November 14, 2014

**BOARD OF COUNTY COMMISSIONERS
ORANGE COUNTY, FLORIDA
ADDENDUM NO. 2 / IFB Y15-721-EZ**

**ORANGE COUNTY CLARCONA HORSEMEN'S PARK KITCHEN AND REC BUILDING HVAC
REPLACEMENT**

1 SECTION THROUGH ATTIC, KITCHEN AND STORAGE ROOM
 A401 SCALE: 1/2" = 1'-0"

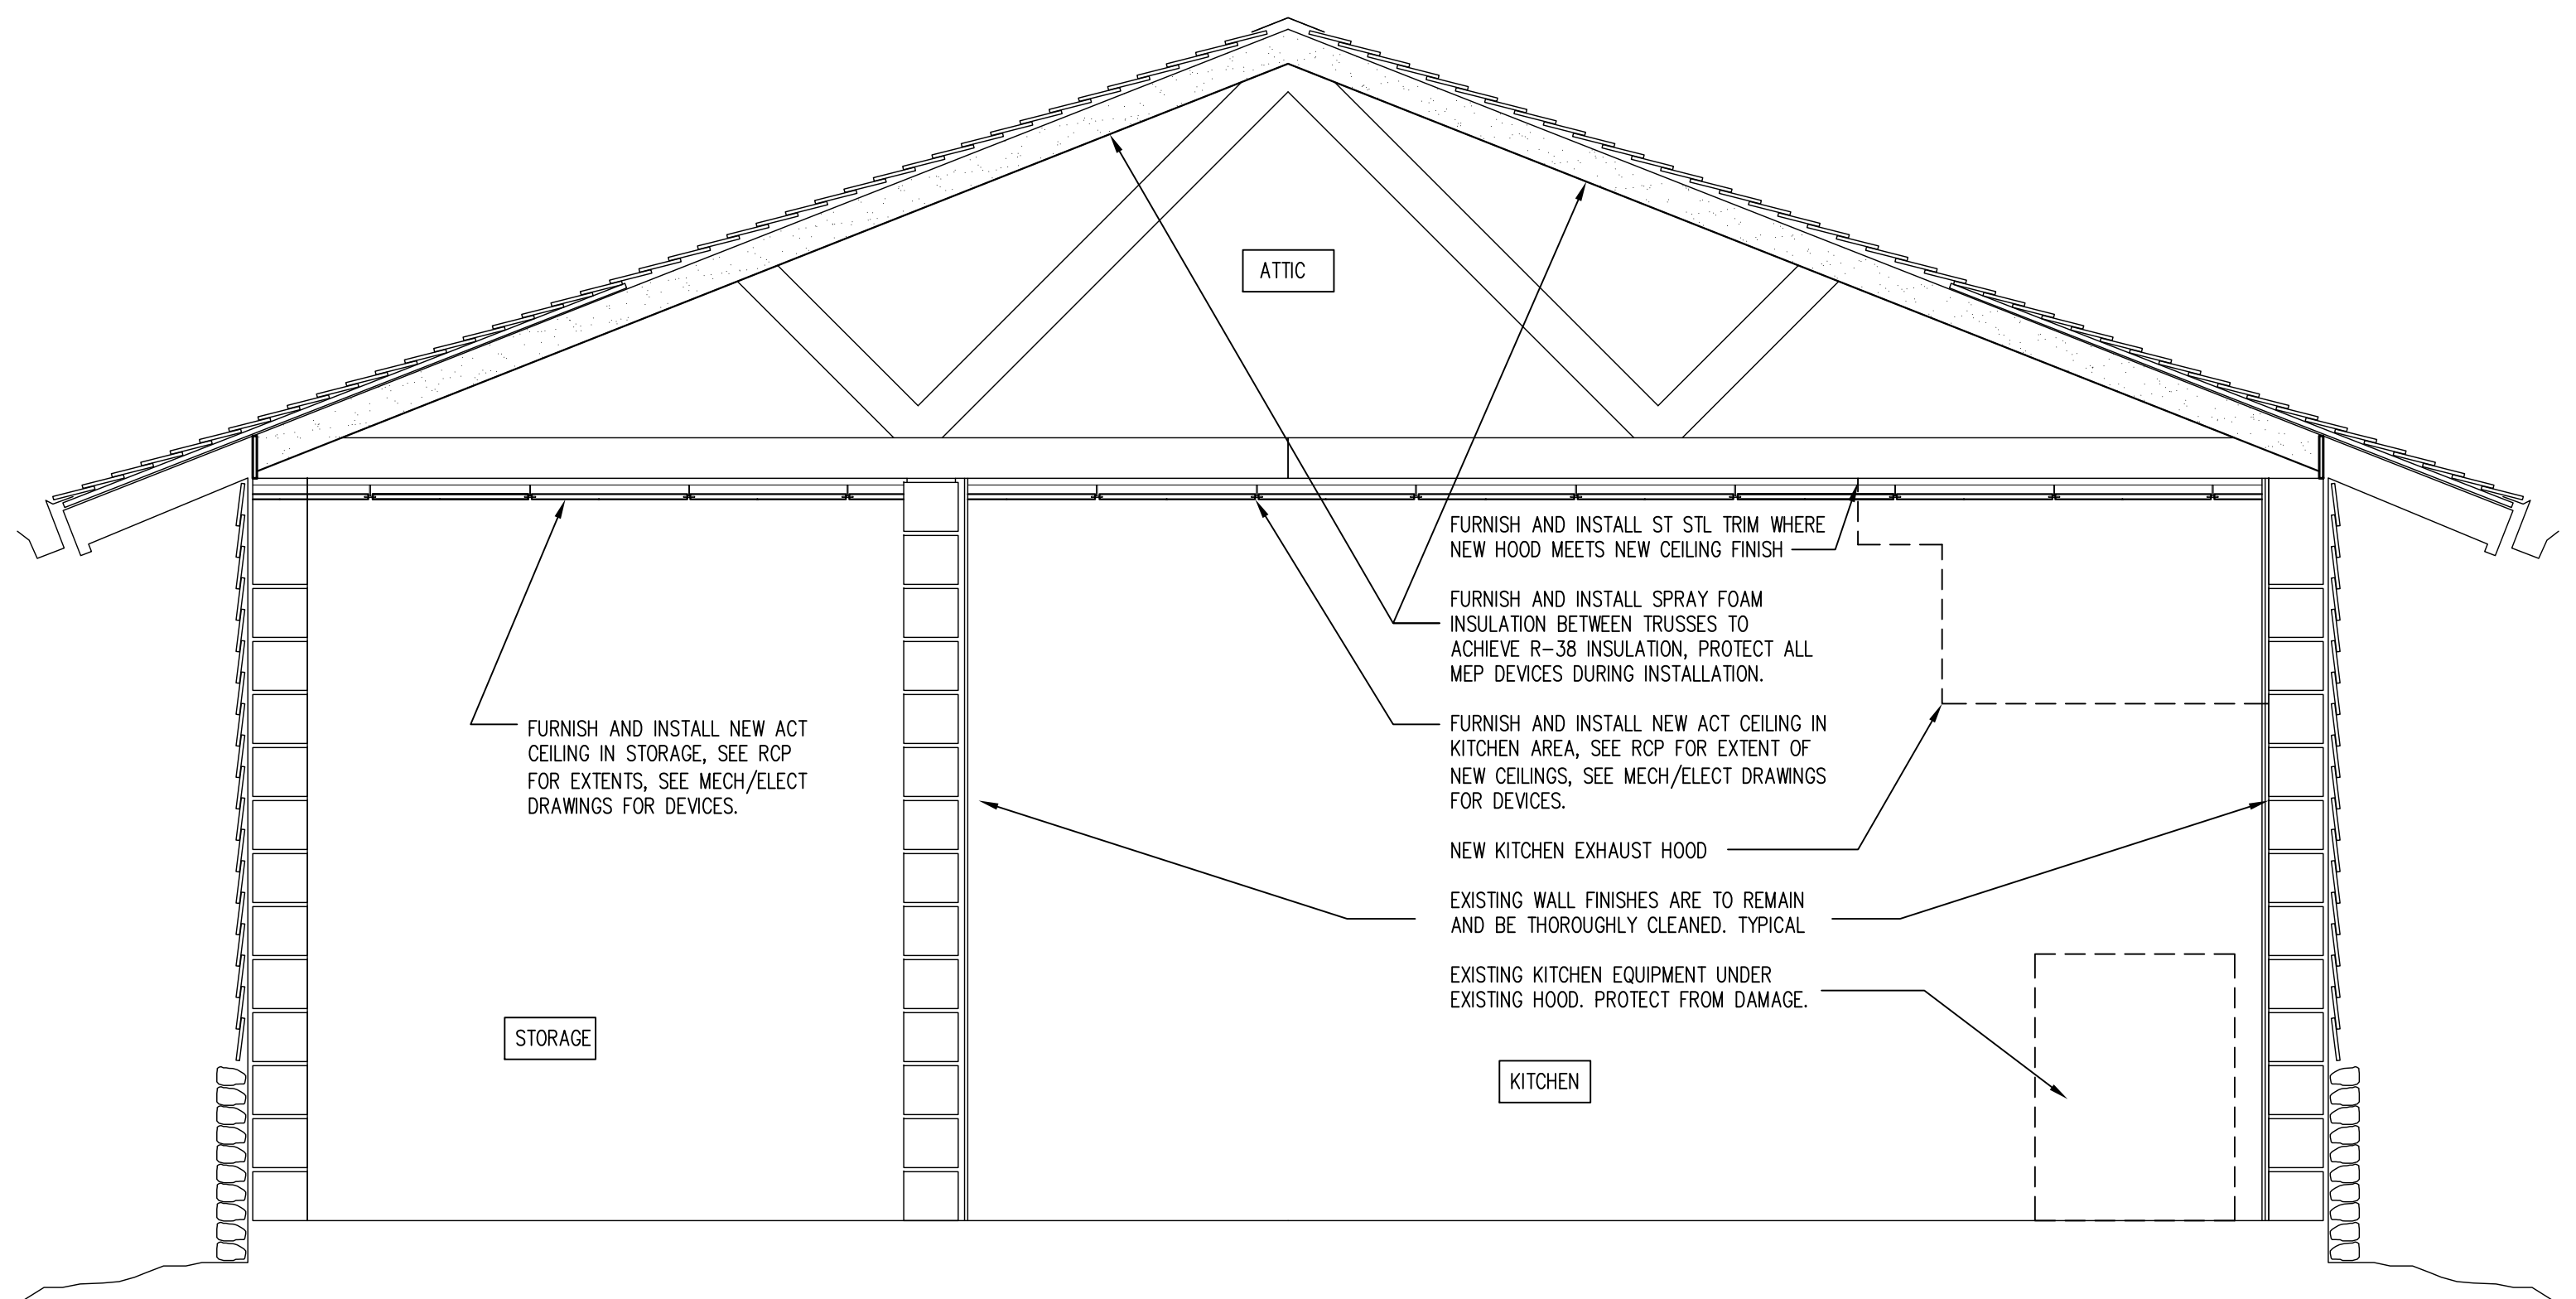
- h. DRAWING SHEET NO. A201 – EXTERIOR ELEVATIONS
 - (1) Revise Hex Notes 1, 4, and 5.
- i. DRAWING SHEET NO. A401 – SECTION AND INTERIOR ELEVATION
 - (1) Revise Hex Notes 1, 4, and 5.

- (2) Revise notes.
- j. DRAWING SHEET NO. A402 – DETAILS
 - (1) Revise Details 1, 6, and 7.
 - (2) Added comment “Provide top rail at all fencing (Typical)” to details 4/A402 and 7/A402.

A402

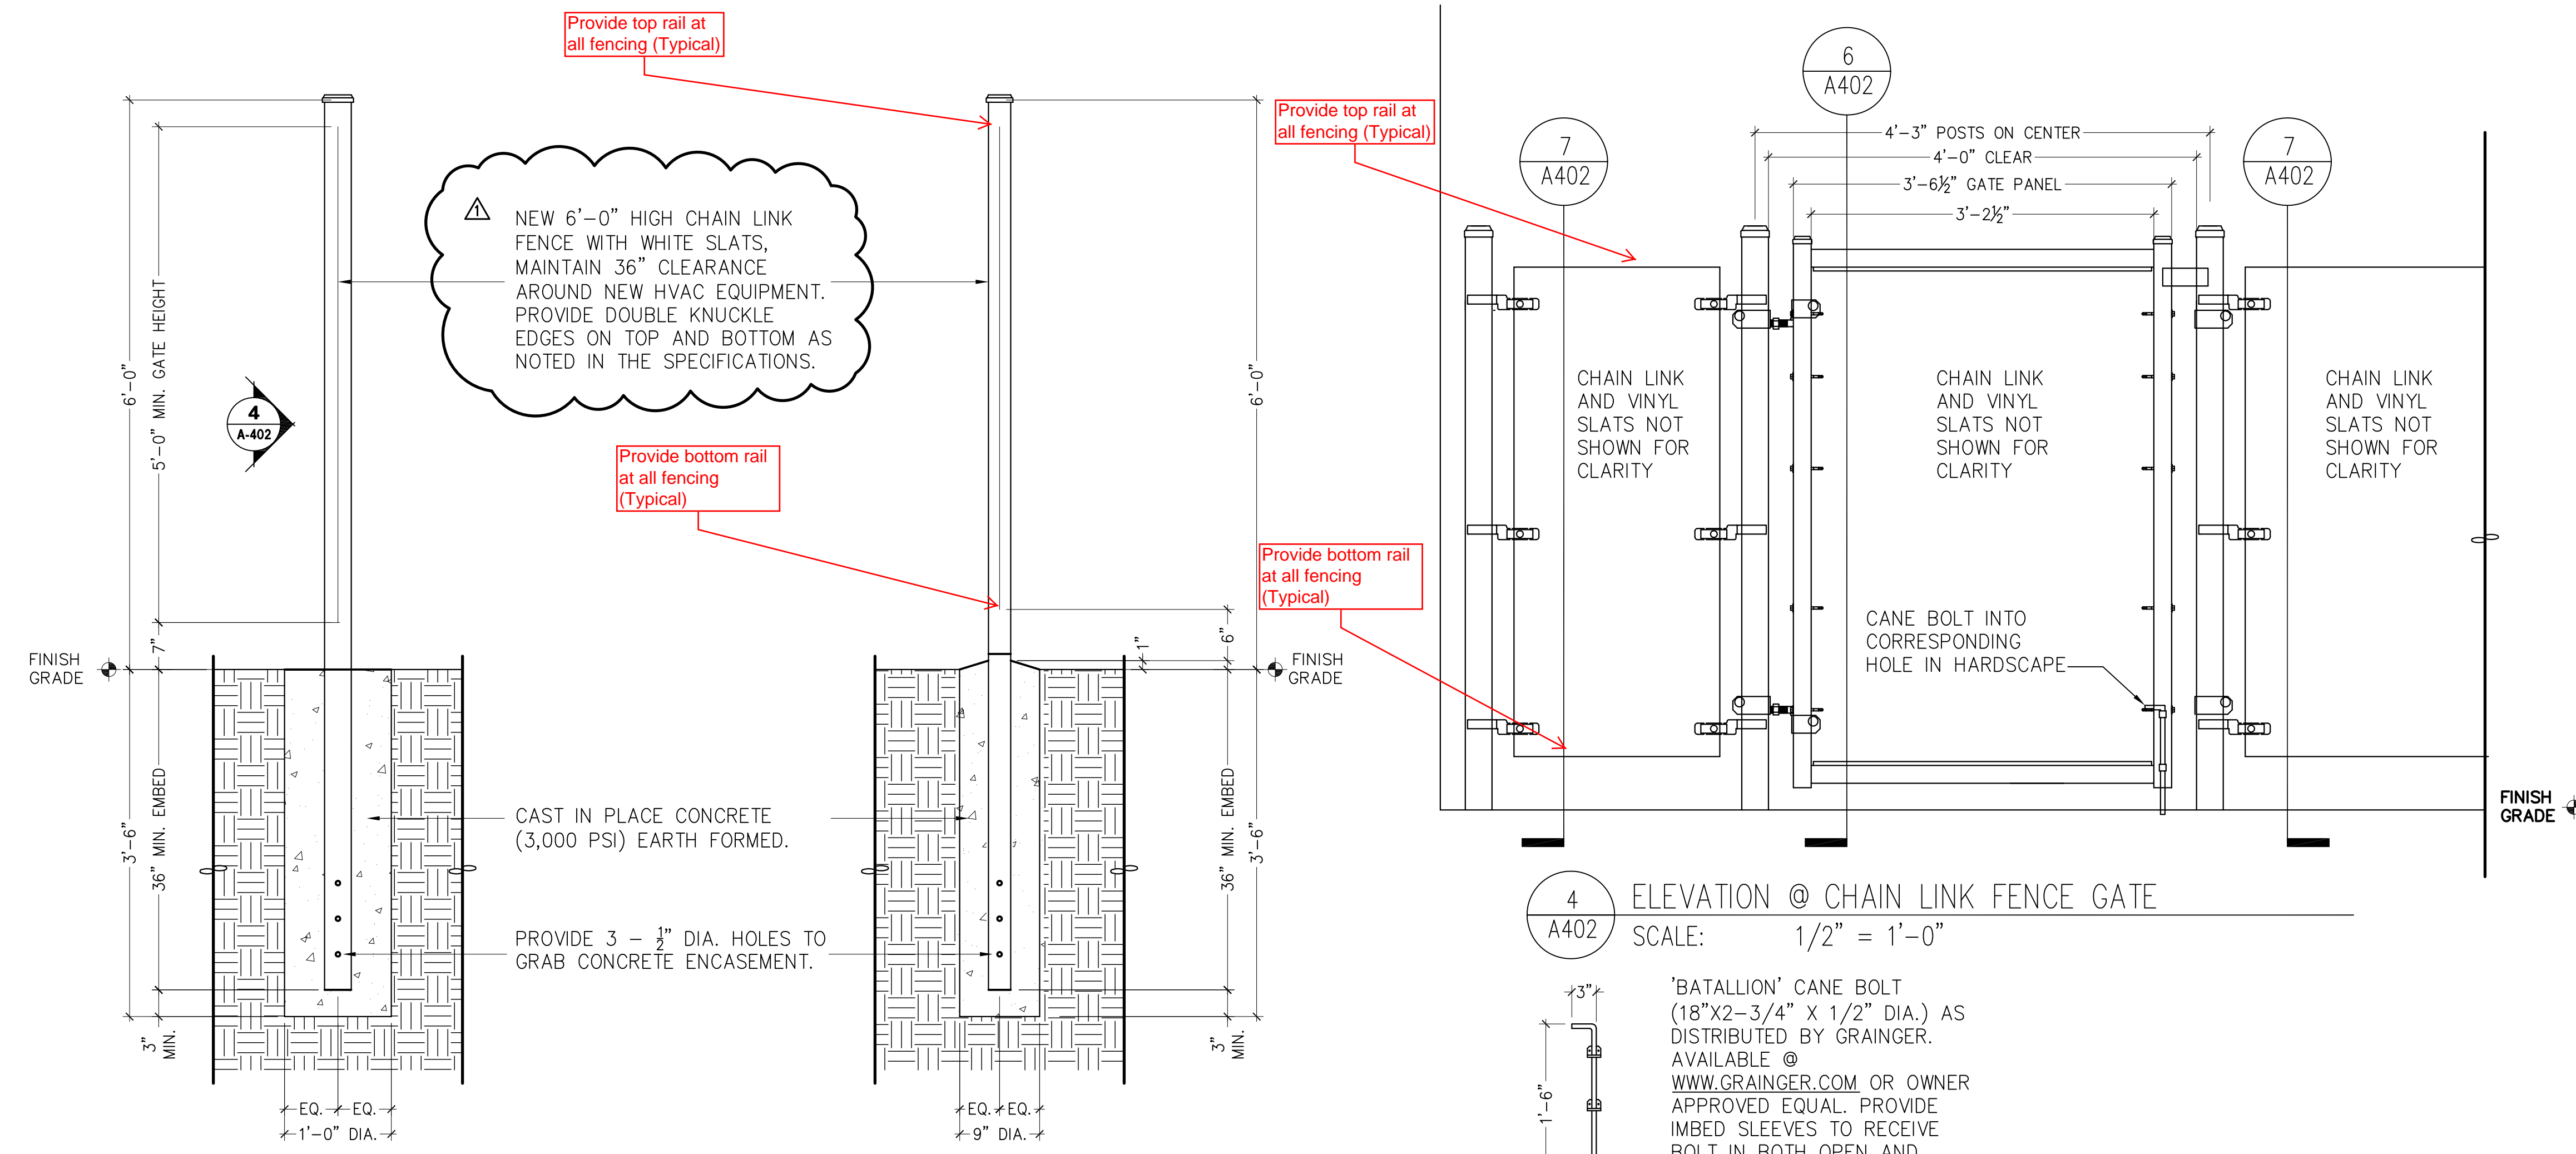
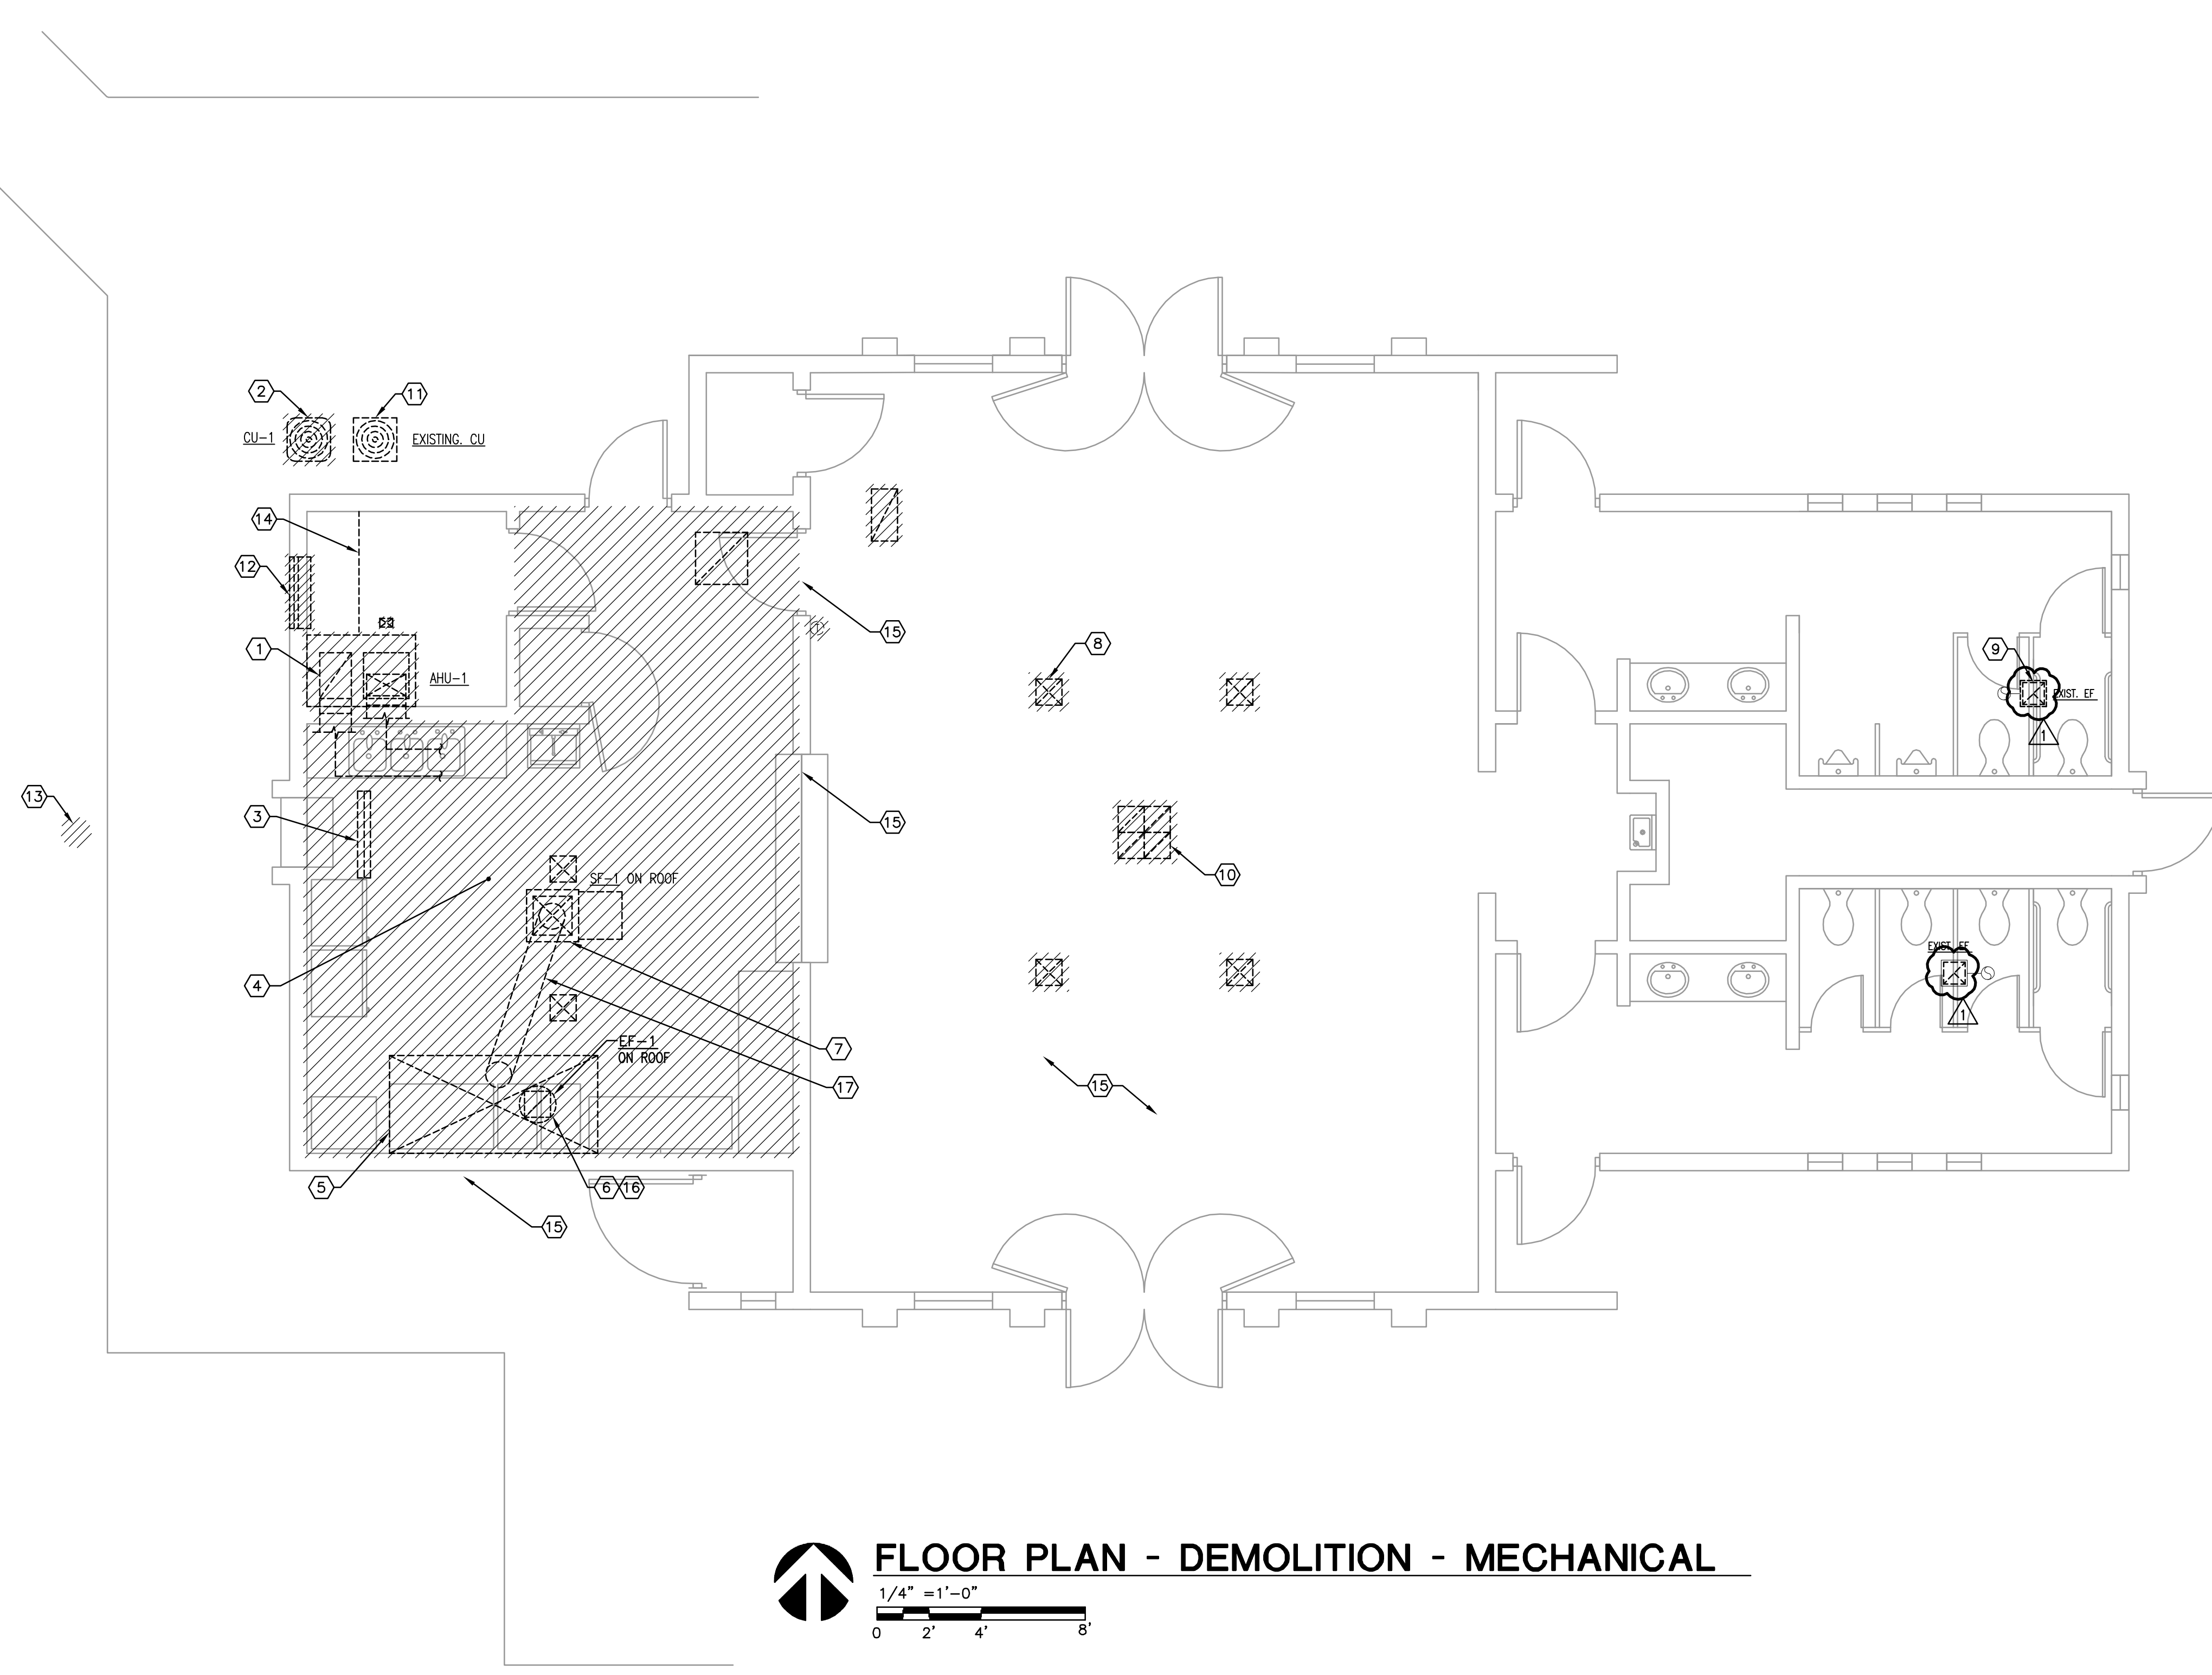
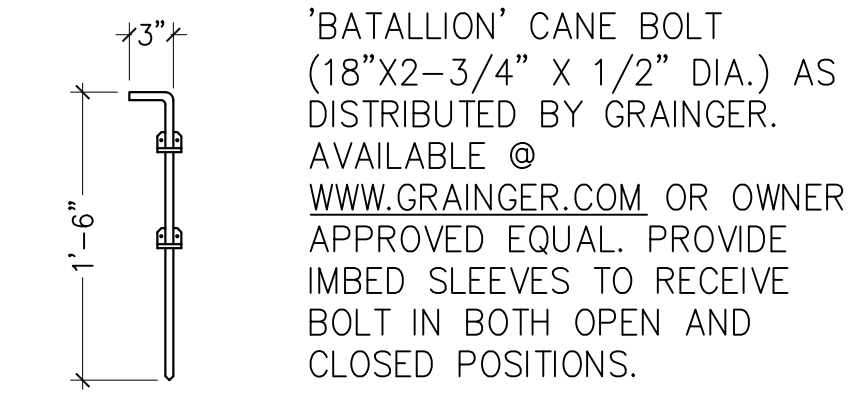
- (3) Added comment “Provide bottom rail at all fencing (Typical)” to details 4/A402 and 7/A402.
- k. DRAWING SHEET NO MD101 – FLOOR PLAN – DEMOLITION - MECHANICAL
